**Subject: Application for License Proposed Modification to the Generation License under NEPRA Licensing (Application, Modification, Extension and Cancellation) Procedure Regulations, 2021, on behalf of 2x660 MW Thar Coal Block-1 Power Generation Company (Private) Limited**

THAR COAL BLOCK-1 POWER GENERATION COMPANY (PVT) LTD

(g). **Plant Characteristics:**

**Table-2 in Petition**

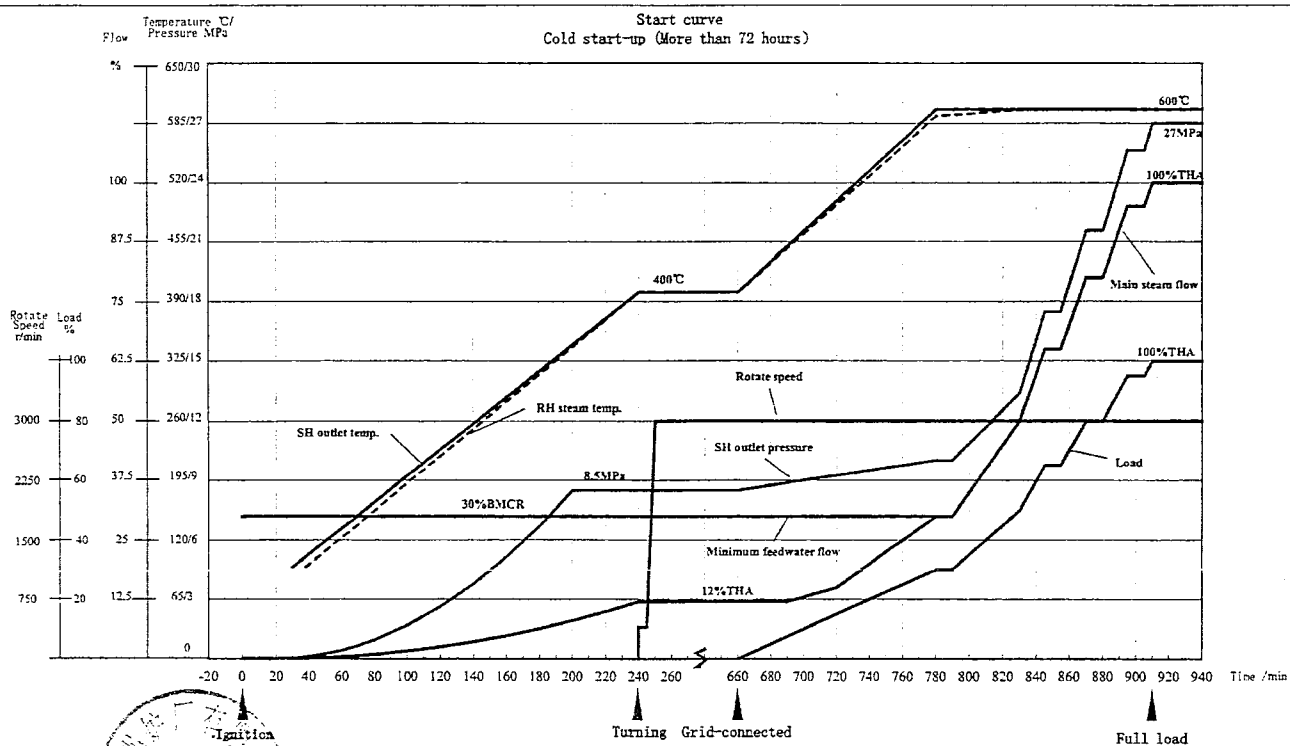
The changes are in the *Ramping Rate (%/min)* and *Time Required to Synchronize to Grid (min)* as these values were indicative at the time of application of Generation License and hence these parameters as set out in row (v) and (vi) of schedule I of the Generation License (under the heading ("Plant Characteristics")) are proposed to be modified as follows in accordance with the OEM data:

<b>Length of Shutdown</b>	<b>Notice required synchronizing (The time start after boiler ignition)</b>
Not more than 1 hour	95 min
More than 1 hour but less than 10 hours	140 min
More than 10 hours but less than 72 hours	395 min
More than 72 hours	600 min

**Revised Table-2**

<b>Length of Shutdown</b>	<b>Notice required synchronizing (The time start after boiler ignition)</b>
Not more than 1 hour	240 min
More than 1 hour but less than 10 hours	300 min
More than 10 hours but less than 72 hours	720 min
More than 72 hours	990 min
